BULLETIN NO. 090819U

PRODUCT: UB90-50/75/100 Boilers

TITLE: New Inducer motor/blower assembly

PHOTO 3: Flue pipe clearance

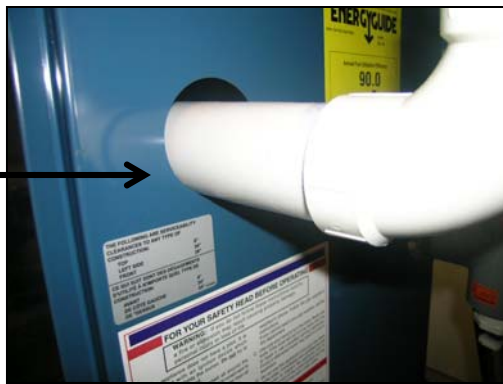
- The inducer must not be allowed to support the weight of the PVC vent pipe. The vent pipe must be properly supported with brackets or pipe hangers secured to the structure.
- Check for vibration transmission between the flue pipe where it passes through the boiler jacket. Contact at the jacket penetrations can transmit unwanted sound transmission. See photo 3.
- When penetrating the side wall, always be sure to leave enough room for expansion and contraction of the vent pipe. 1/8 to 1/4 inch clearance around the pipe is recommended with a thin layer of sealant to seal the opening if required. See photo 4.

Flue pipe resting on boiler jacket can transmit inducer sound.
